City of Newton Planning and Development

Petition: #447-22

December 13, 2022

106 River Street

Revised Site Plan

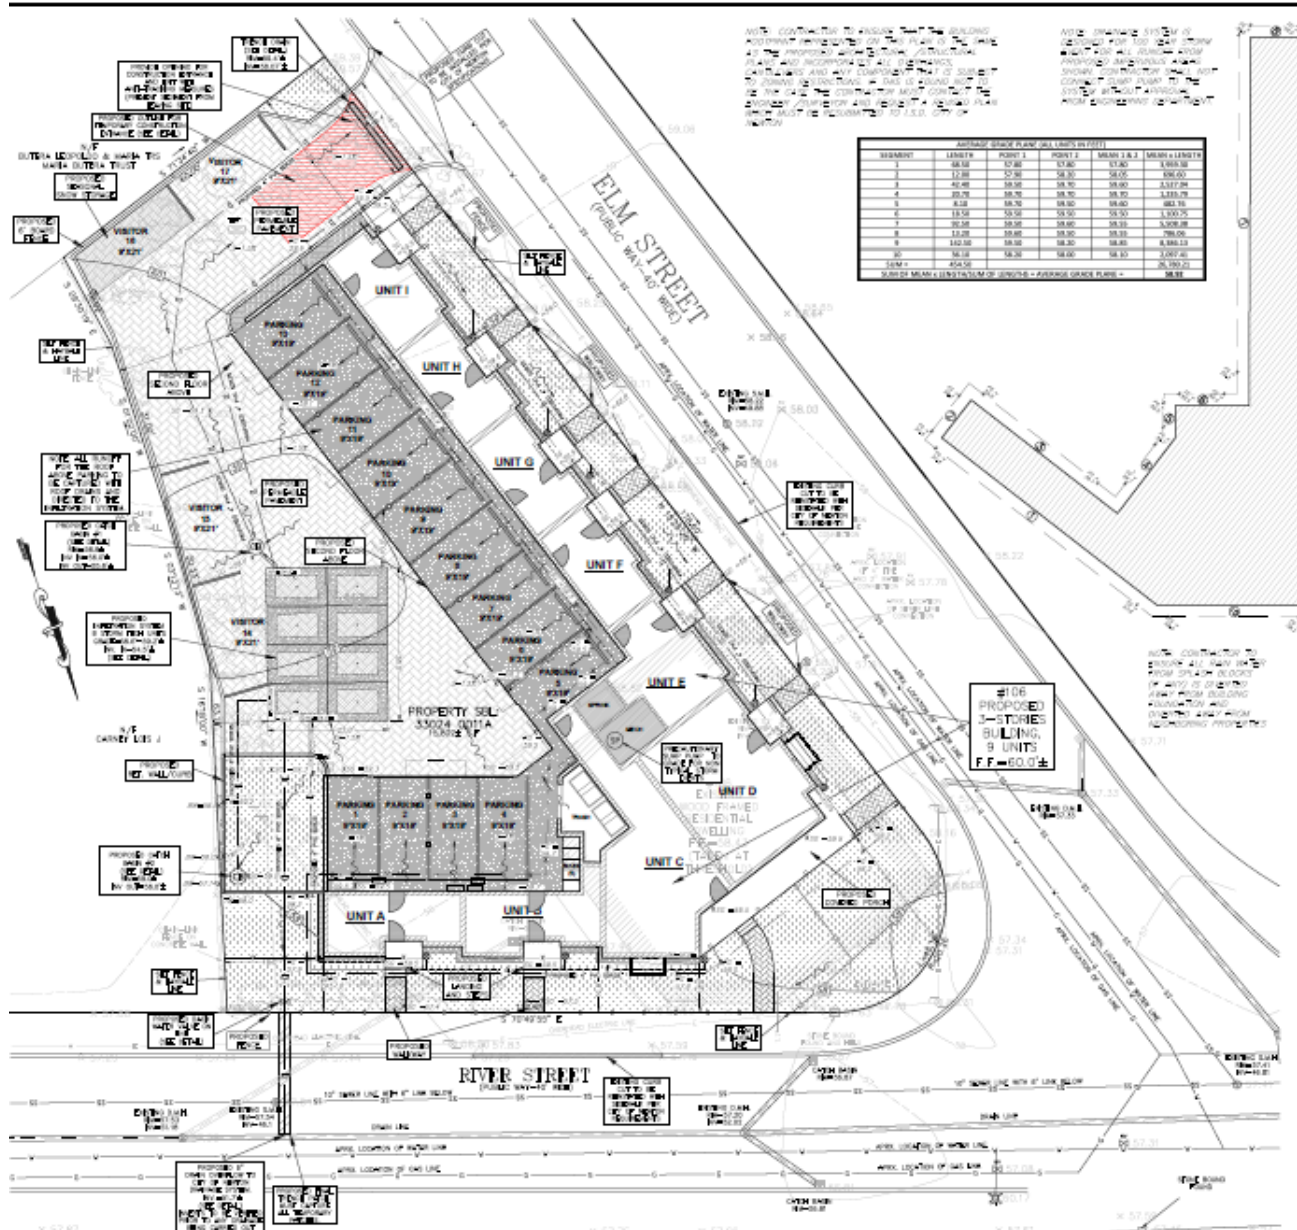
- **Removed two parking stalls**
 - As a result, additional waiver needed for two parking stalls
 - Waiver for restricted end stalls no longer needed
- Revised landscape plan
- Bike parking added
- Additional landscaping
